Addendum No. 01

Subject: Edward T. Steel Elementary School – Emergency Generator Replacement
SDP Contract No. B-057 (C) of 2016/17

Location: Edward T. Steel Elementary School
4301 Wayne Ave.
Philadelphia, Pennsylvania 19140

DRAWING NO.
E101

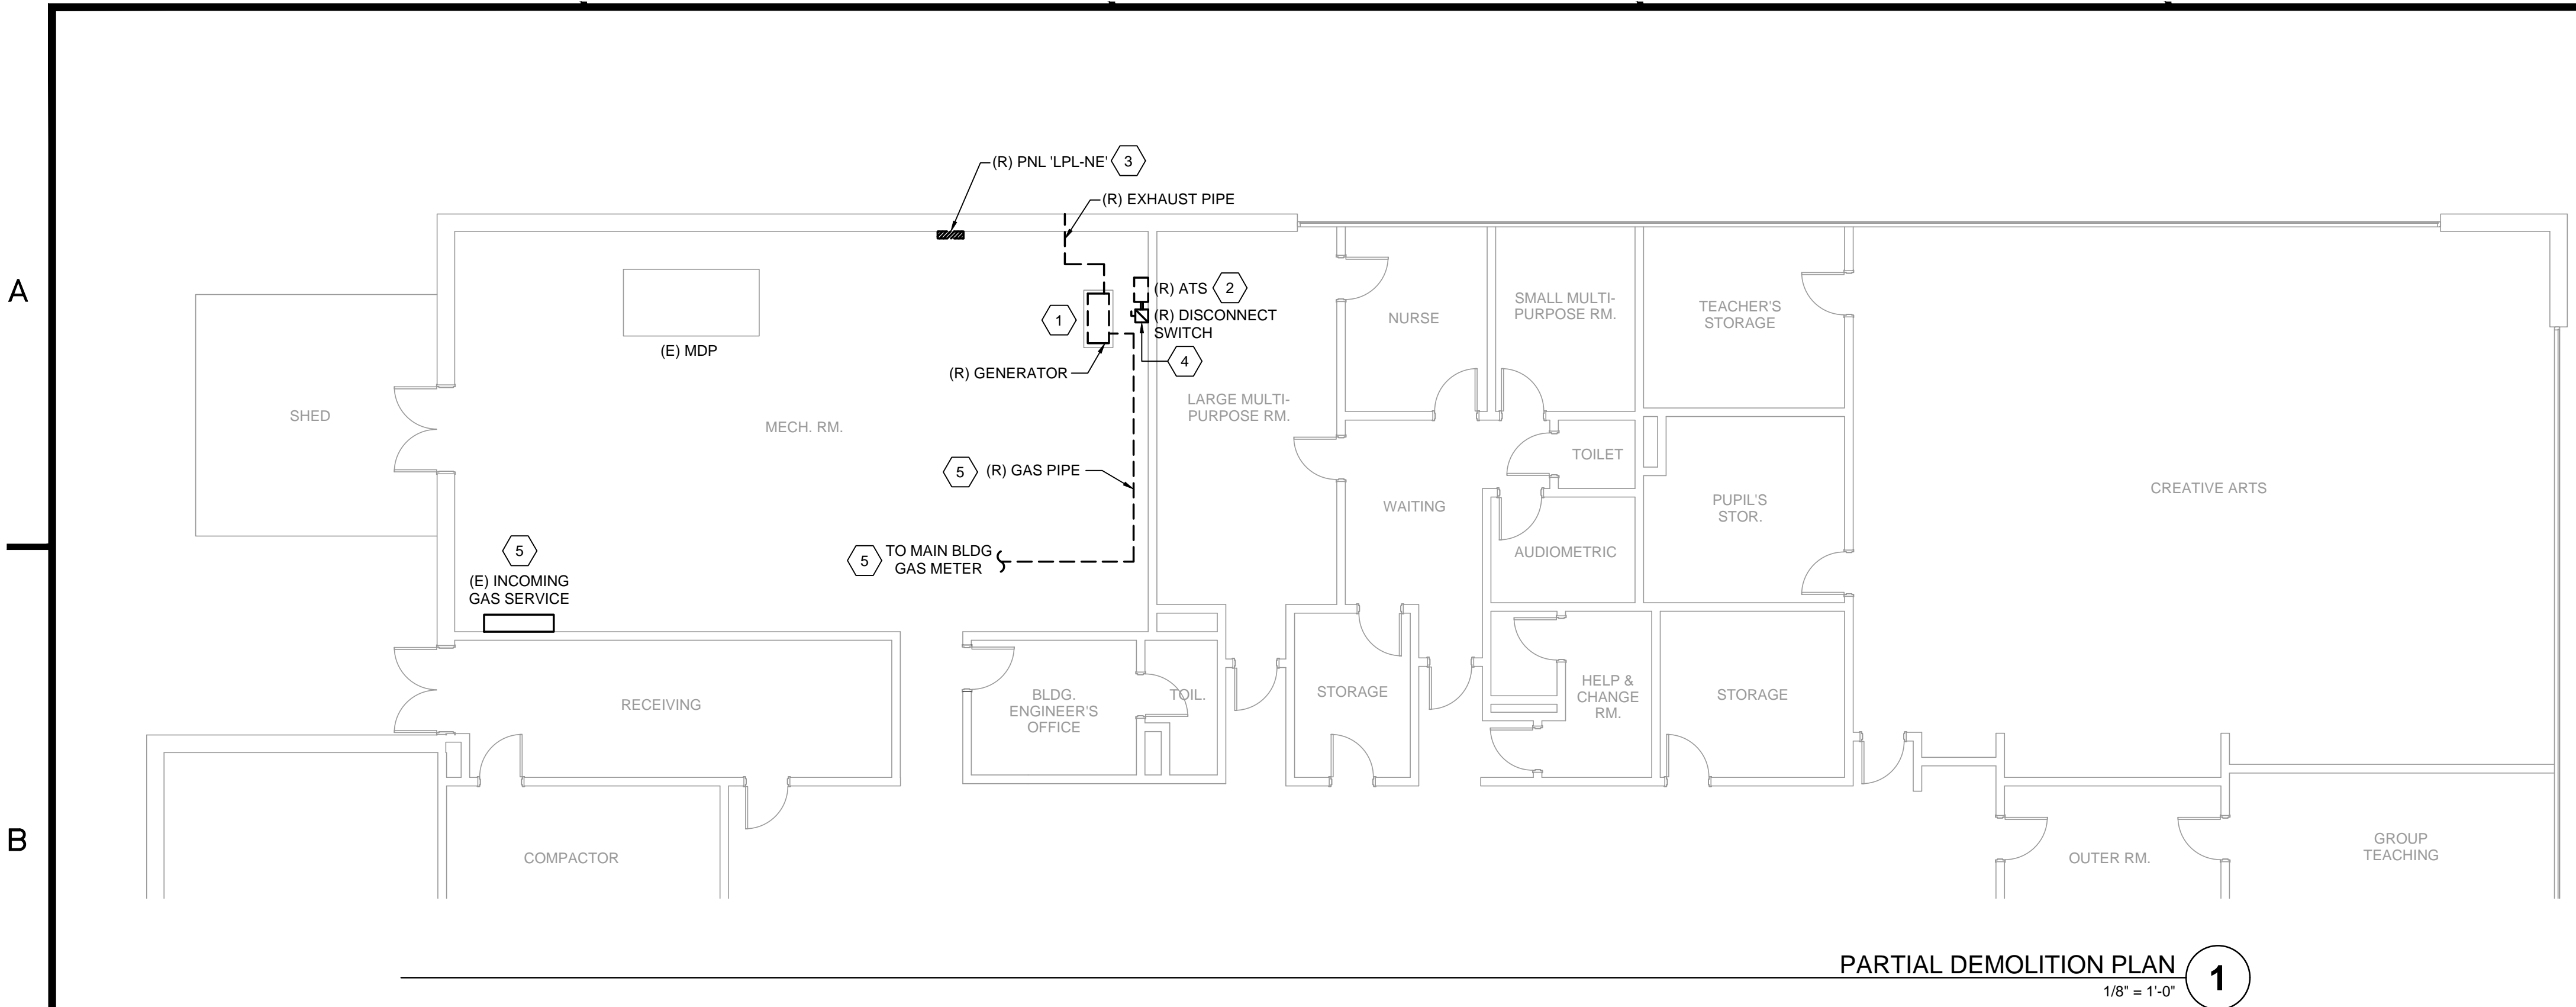
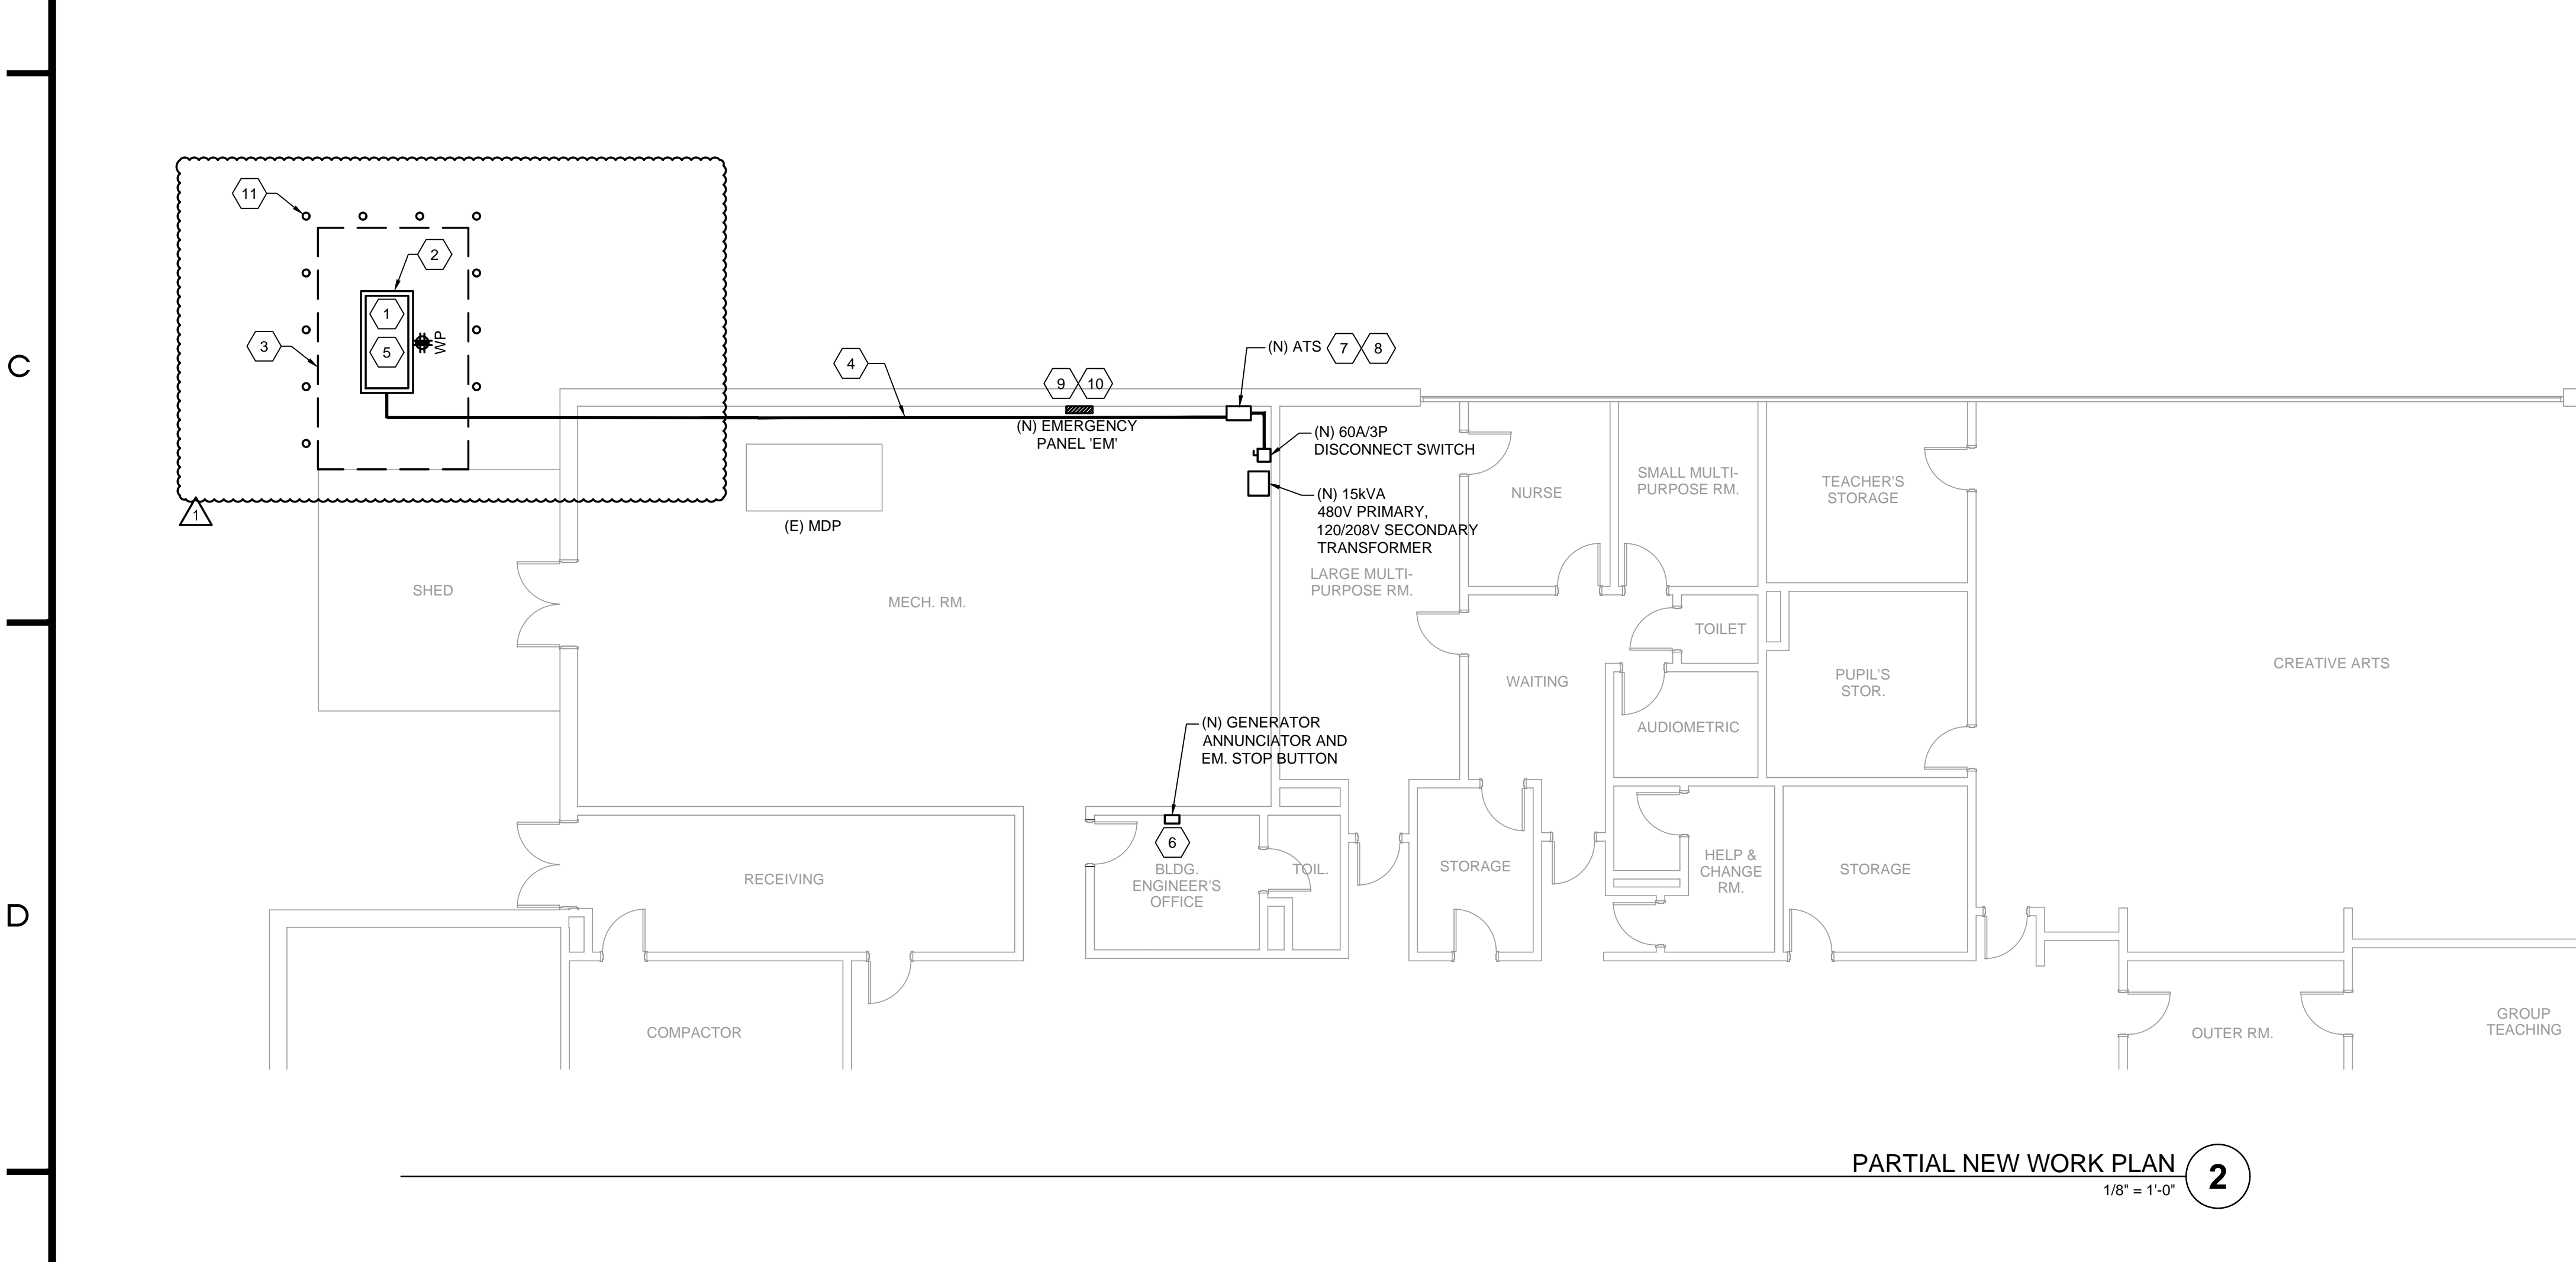
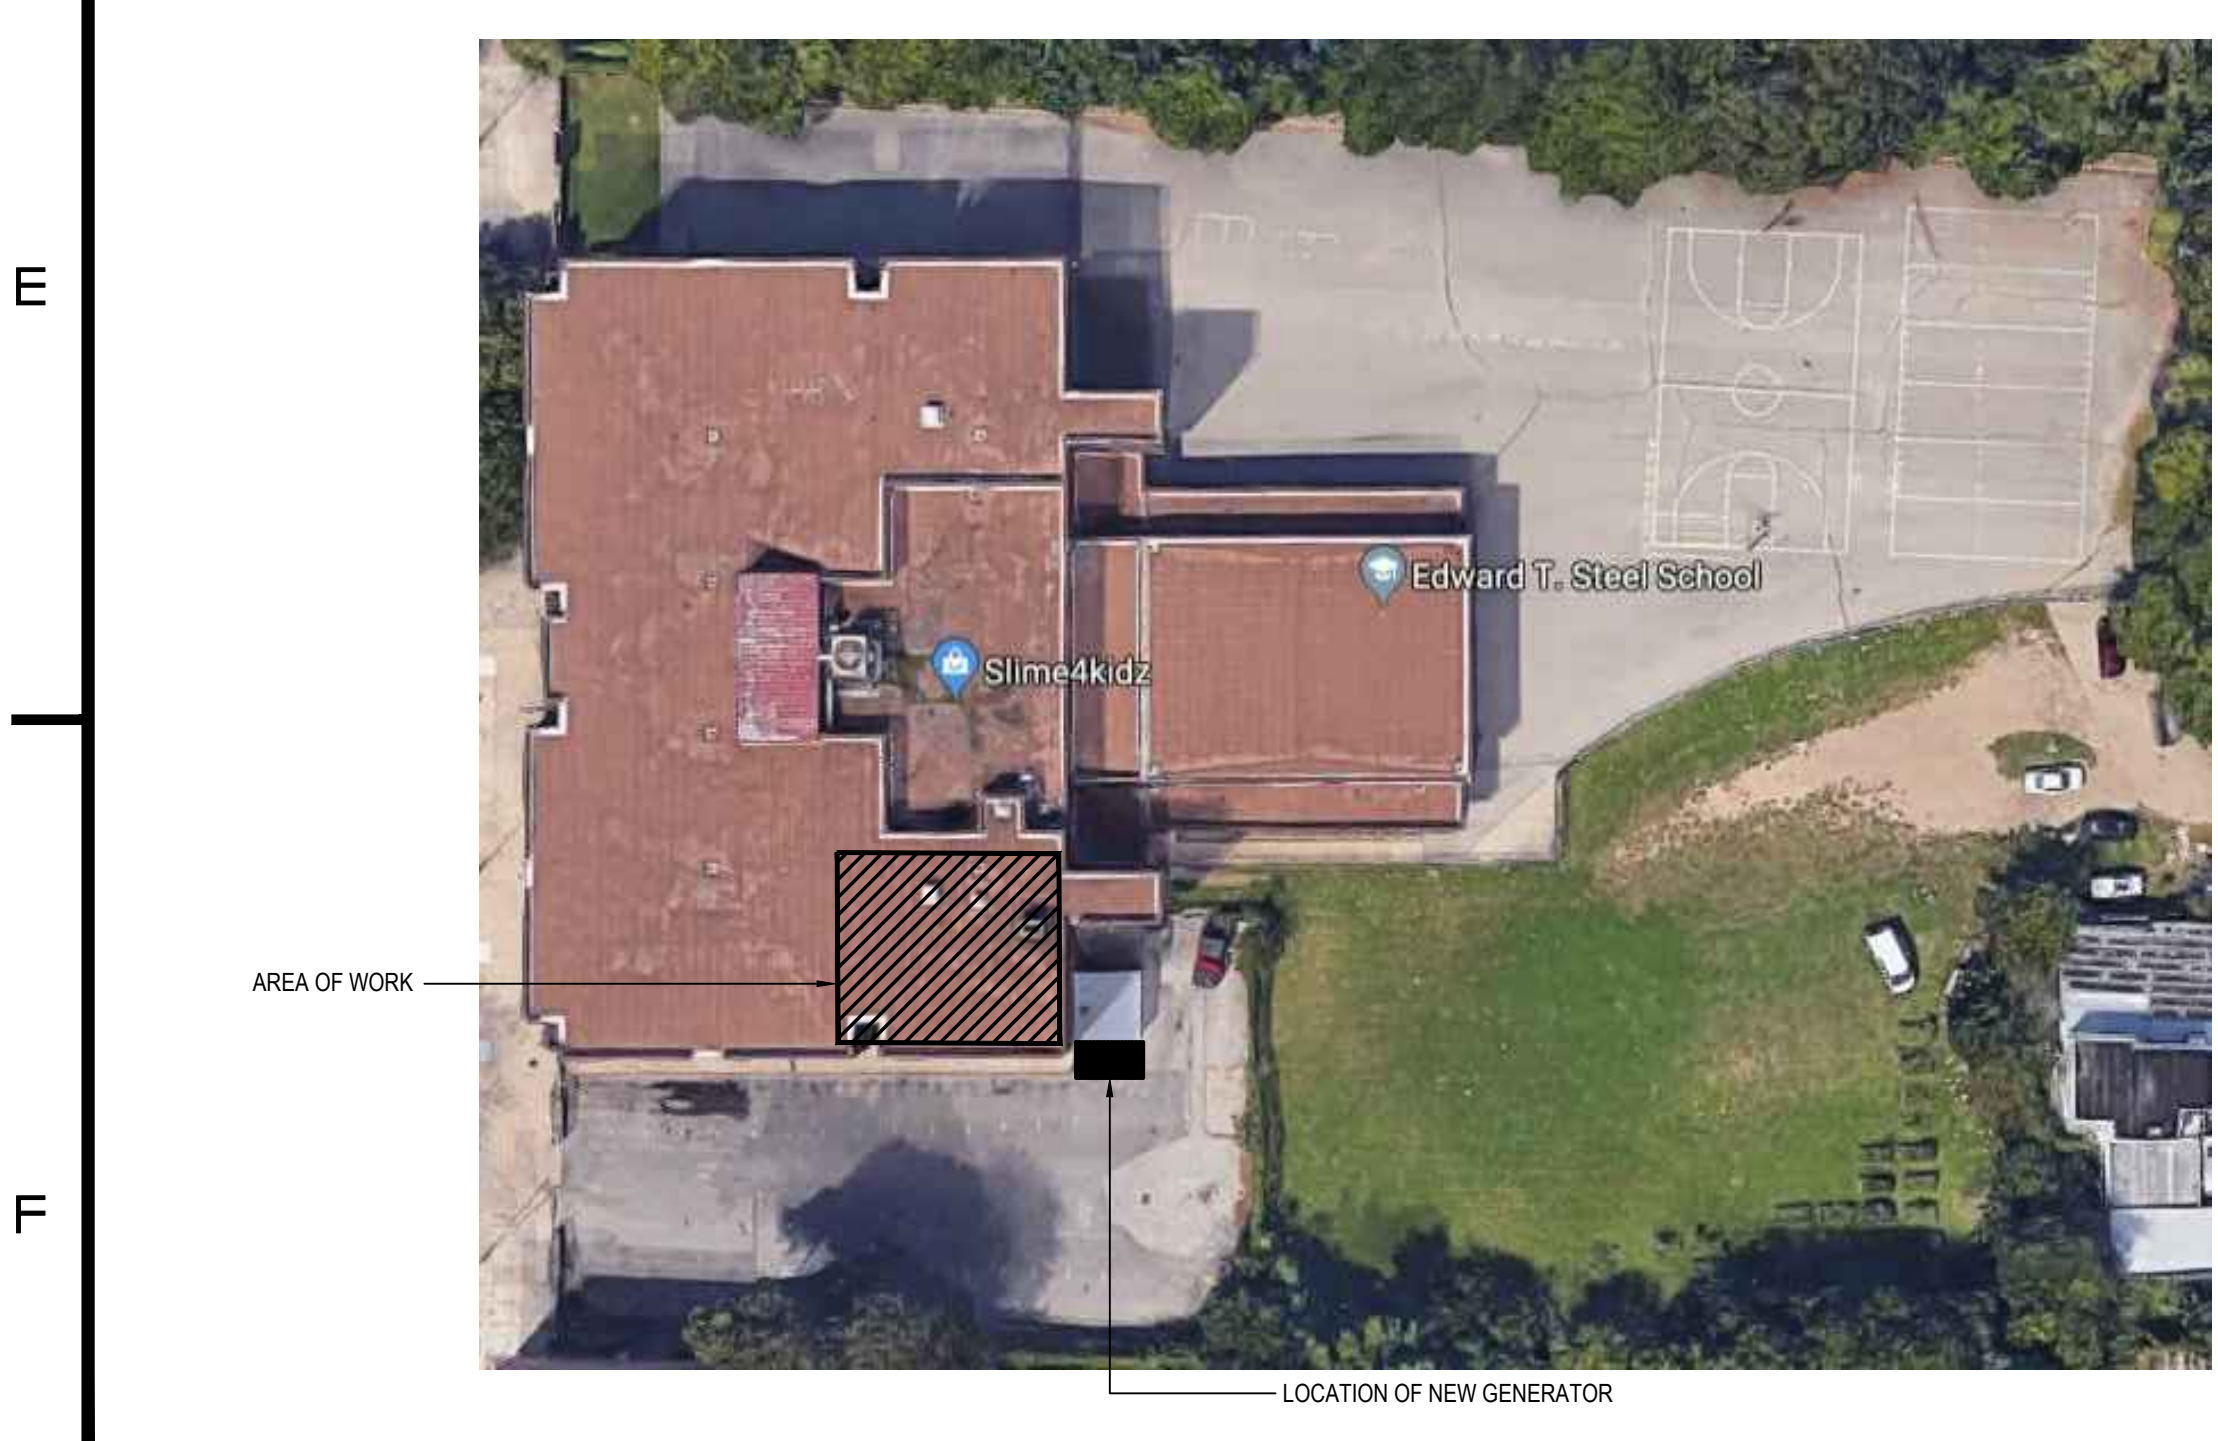
E101 – Revised generator location and bollards have been added. Conduits from the generator outside the building shall be routed under-ground.

Response – Yes, as indicated on drawing E101, the electrical contractor is responsible for all demolition of existing equipment and feeders.

Response – Bollards are required to protect the fence. See updated drawing E101 and E501

Response – The generator shall be located with required clearance away from any existing utilities. See updated drawing E101.

TYPICAL BOLLARD DETAIL 7
NOT TO SCALE

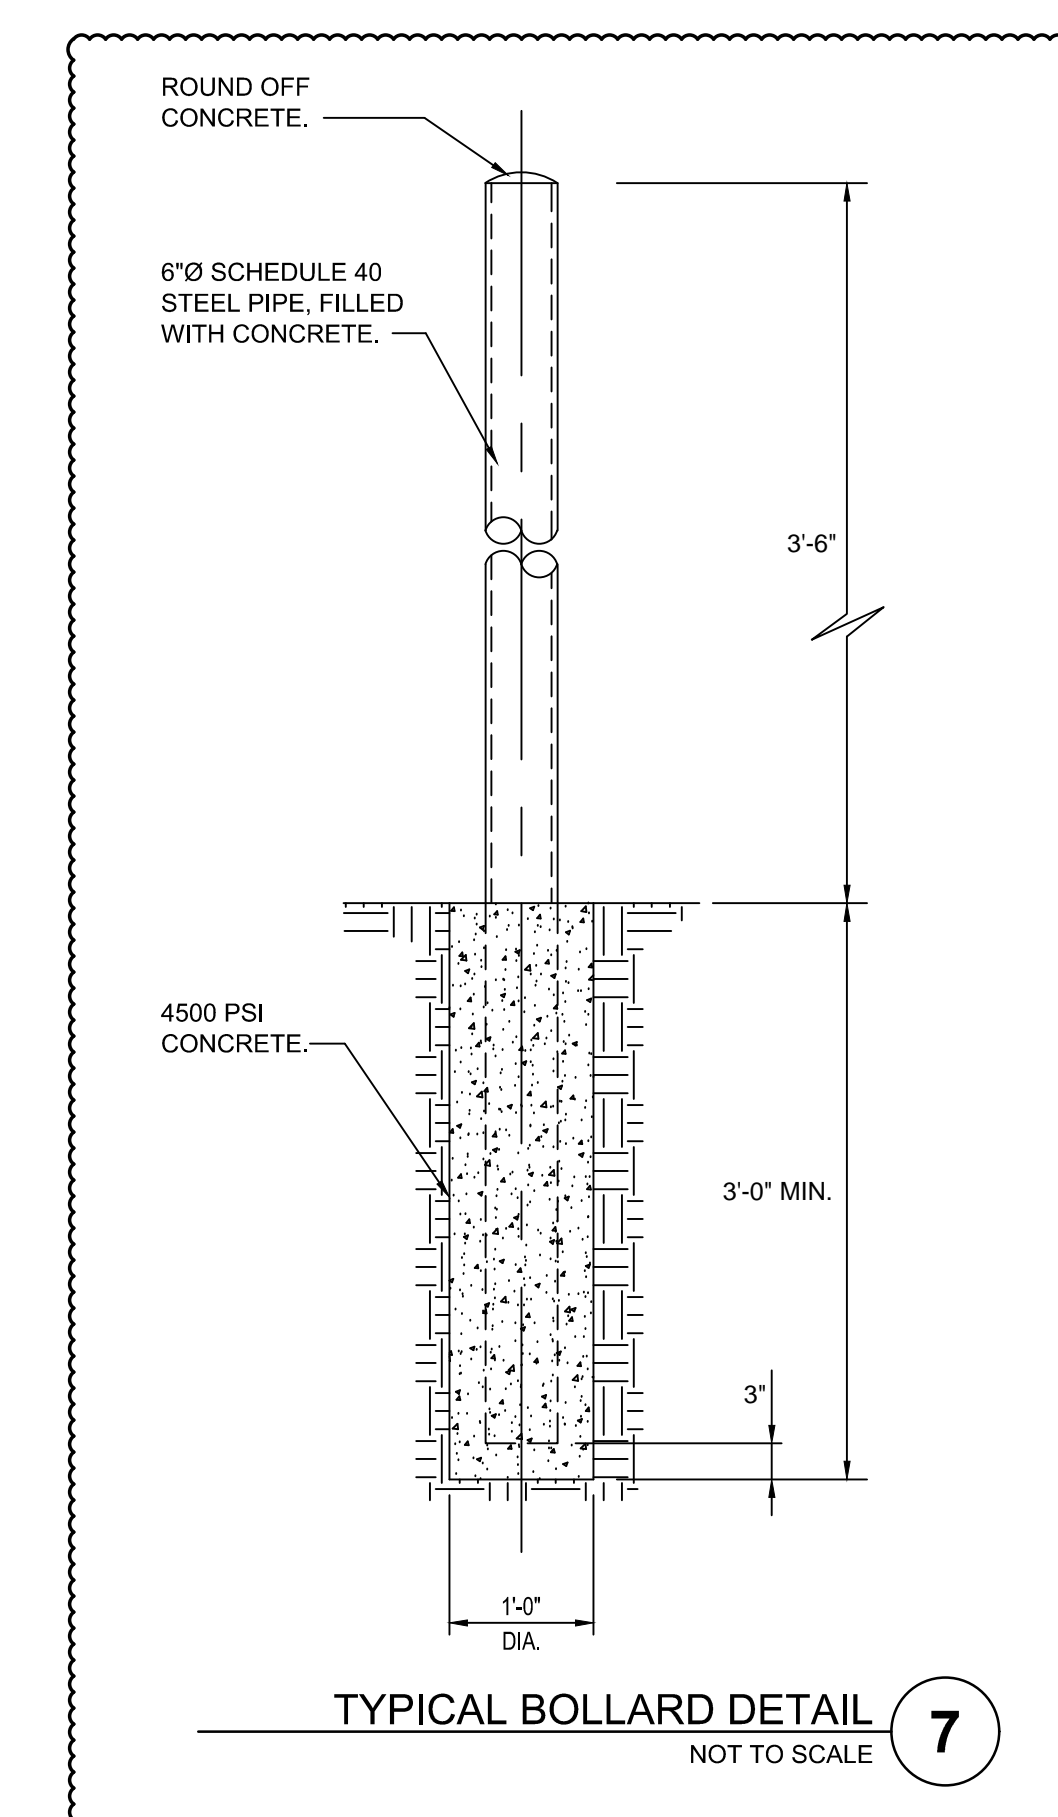
E501 – Added bollard and conduit routing details.
